**DATA RESPONSE SUPPLEMENT #1**  
**FOR**  
**INLAND EMPIRE ENERGY CENTER**  
**SUBMITTAL 6**

**FOSTER WHEELER ENVIRONMENTAL CORPORATION**

**May 17, 2002**

**Figure 87A-1**

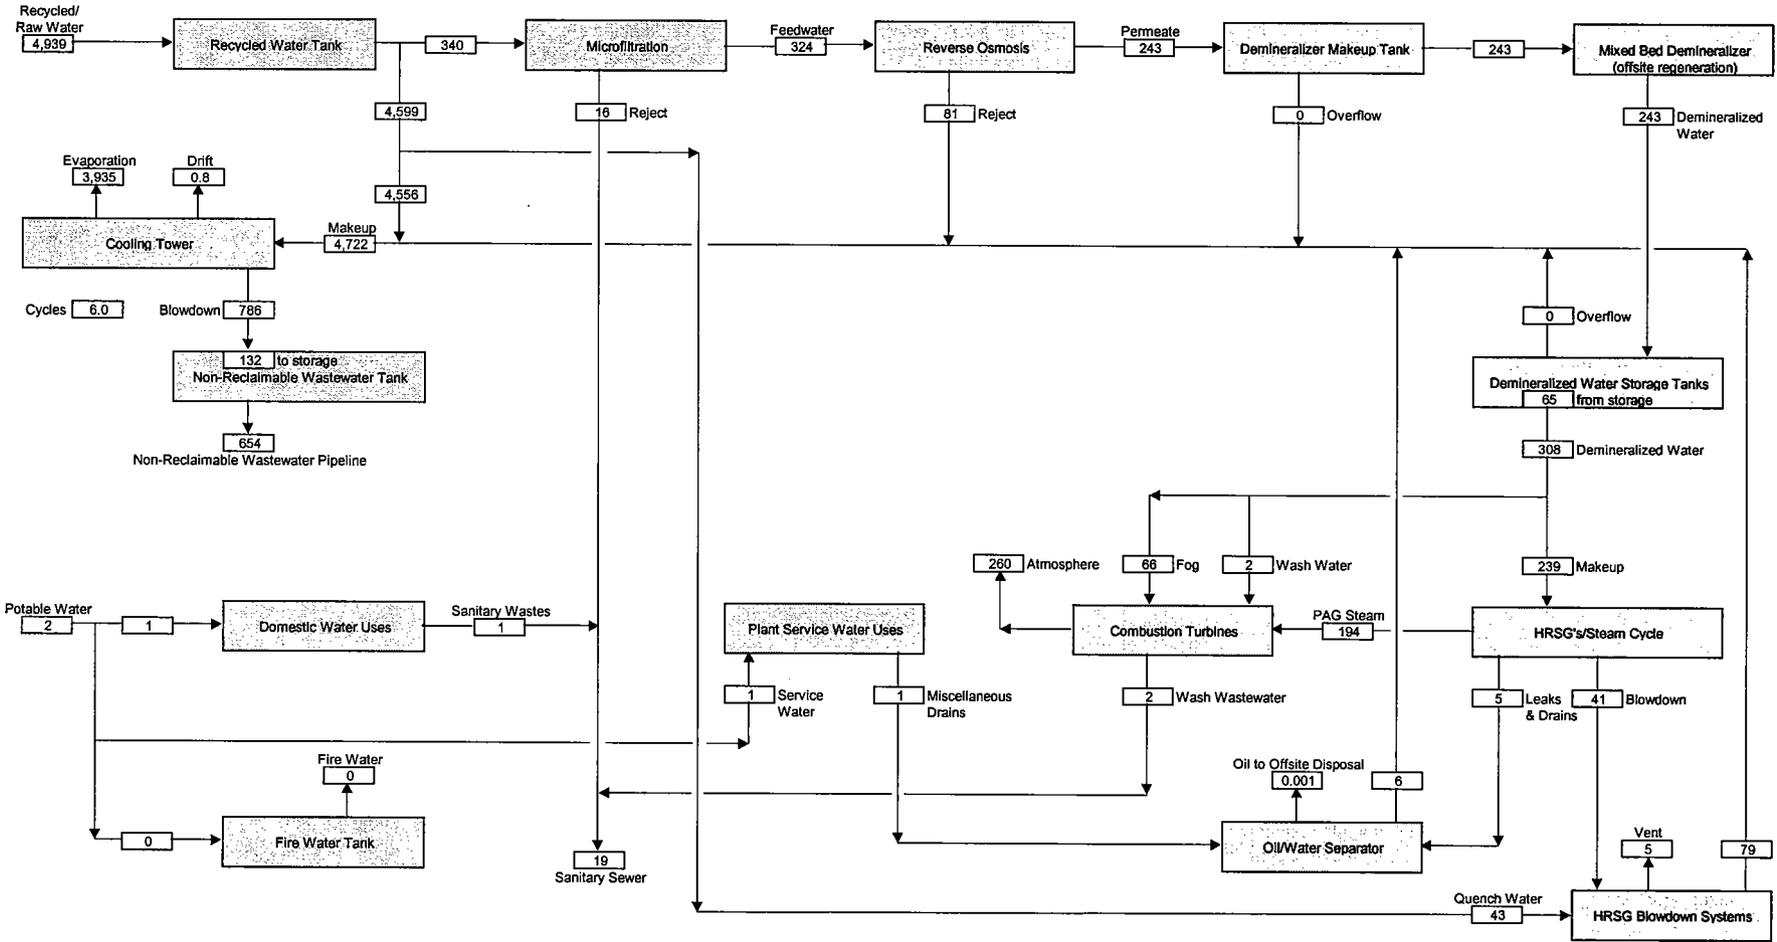
**Response #87A** - The Applicant has conservatively assumed a worst case water quality based on the highest concentration of each constituent found in the three water sources; 1) Perris Valley RWRf recycled water, Moreno Valley RWRf recycled water, and San Jacinto Tunnel raw water. While the San Jacinto Tunnel raw water is higher in many scale-forming constituents,

with advanced treatment chemistry, it can actually be cycled higher in the cooling tower than either of the recycled water sources. The Applicant estimates that with the San Jacinto Tunnel raw water alone, 10 to 12 cycles of concentration could be achieved, whereas only 6 to 8 cycles of concentration would be possible using recycled water. The reason for this is that the silica concentration in the two recycled water sources (23.4 mg/l for Perris Valley RWRf and 18.7 mg/l for Moreno Valley) is so much greater than that of the raw water source (9 mg/l). Because of the location of the IEEC within Eastern Municipal Water District's (EMWD) recycled water distribution system, the IEEC will normally receive recycled water from the Perris Valley RWRf, which has historically had effluent with higher silica concentrations than that from the Moreno Valley RWRf. In order to conservatively estimate project water demands and wastewater production, the water balances included in the Application for Certification (Figures 3.4-6 and 3.4-7) were prepared assuming 5 cycles of concentration, thus providing a worst-case analysis from a flow perspective. For comparison purposes, Figures 87A-1 and 87A-2 (located in this submittal) present peak day water balances based on 6 cycles of concentration, representing use of Perris Valley RWRf recycled water, and 8 cycles of concentration, representing use of Moreno Valley RWRf recycled water.

**Figure 87A-3**  
**Cooling Tower Makeup and Blowdown versus Cycles of Concentration**

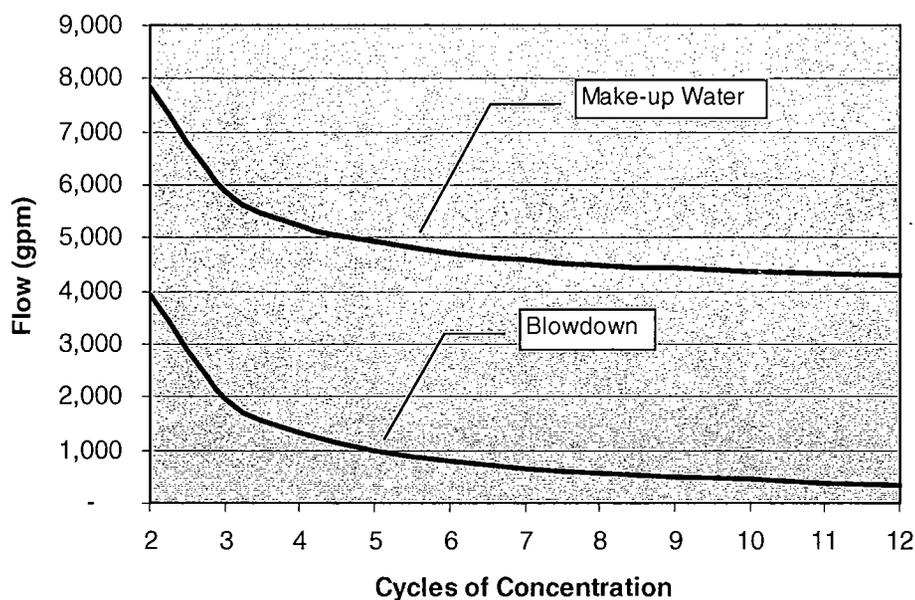
From our meeting with staff and consultants, it is the Applicant's understanding that staff desires to evaluate potential increase in the cooling tower cycles of concentration in an effort to reduce plant water demands and thus eliminate the need for supplemental raw water during the early years of the project. As shown in the water balances included in the AFC (Figures 3.4-6 and 3.4-7), cooling tower makeup is the largest water demand within the plant. As previously stated, the Applicant has conservatively estimated project water demands using 5 cycles of concentration. At 5 cycles, approximately 80 percent of the makeup water goes toward replacing that lost to evaporation and drift (with the drift being less than 1 gpm). The remaining 20 percent

goes toward replacing the water discharged through cooling tower blowdown. As the cycles of concentration are increased, the blowdown is decreased, but evaporation and drift losses remain the same. Figure 87A-3 is a graph of cooling tower makeup and blowdown flow rates versus cycles of concentration, assuming an evaporation rate of 3,935 gpm (per the IIEC peak day water balance). As can be seen from this graph, once beyond about 4 cycles, the curves flatten out with diminishing reductions in makeup and blowdown flows for increasing cycles of concentration. For this reason, exotic means to increase cycles of concentration typically are not considered for cooling towers operating at 4 cycles or better, unless there is a need to eliminate wastewater entirely.
